Bug Report Siglent SDG2000x

Date: 28 March 2021

Bug related to Labview driver SDGXSeries_LabView_Driver_1.0.2.zip

Fig 1.

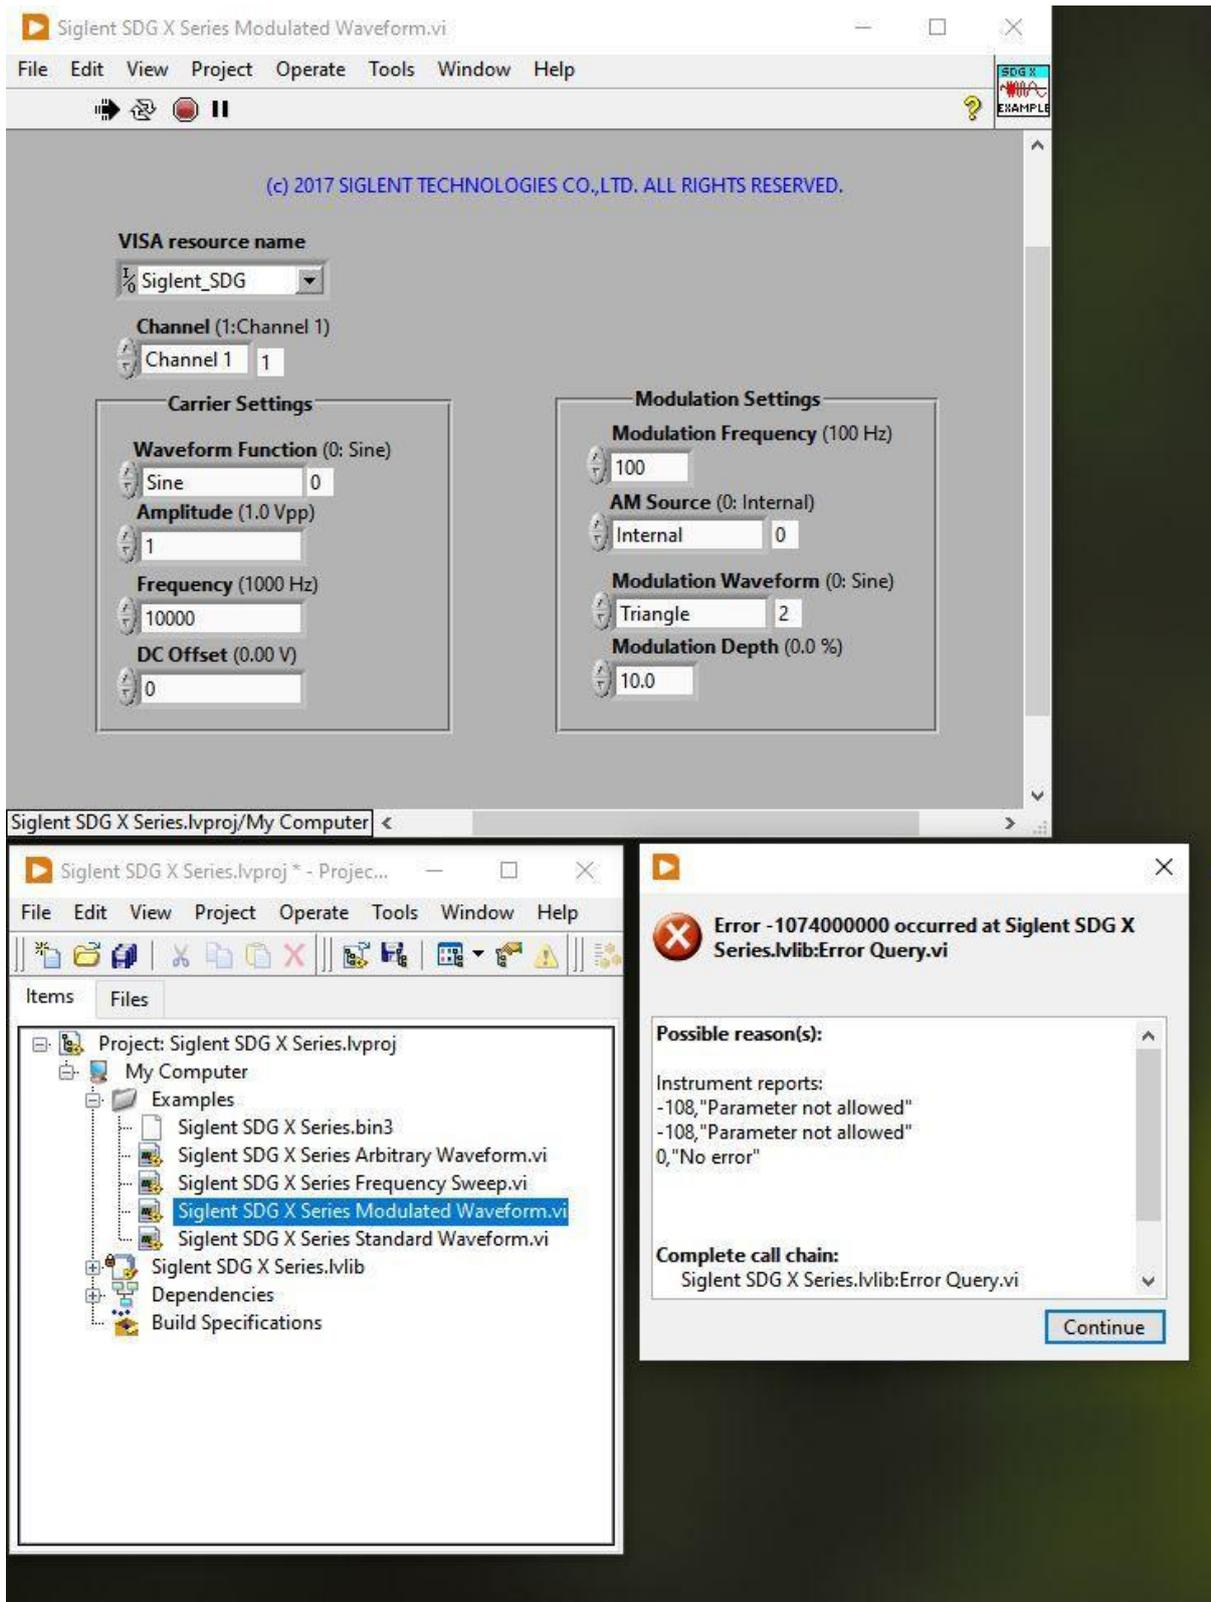
Using the latest published firmware 2.01.01.35R3B2

Gives an error.

See figure1 below.

Partly Resolved

by using firmware 2.01.01.35R3B3 from a zipfile kindly provided by Rob Annandale tautech.nz@gmail.com

Figure 2. Removing the comma's after UP DOWN UP_DOWN resolved the problems.

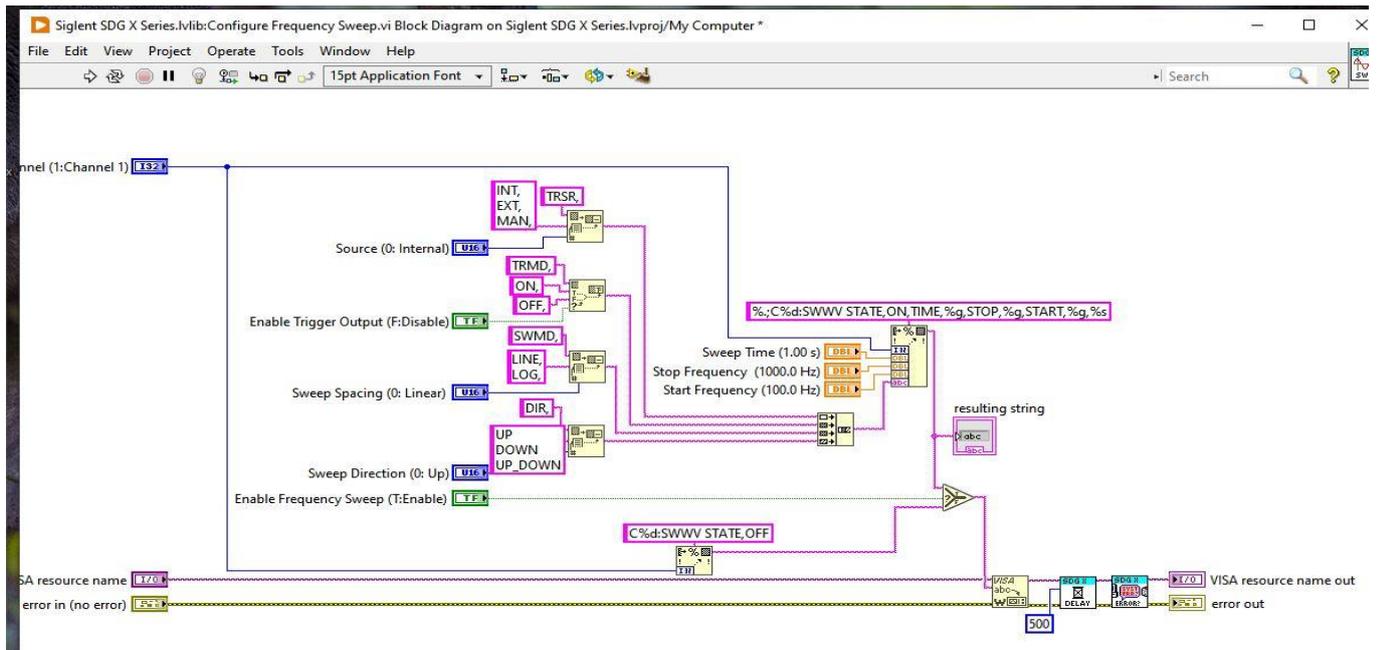
One of the examples from the 1.0.2 zipdriver is not working.

The sweep example has a problem. It has been resolved by removing the three ',' as shown in figure2.
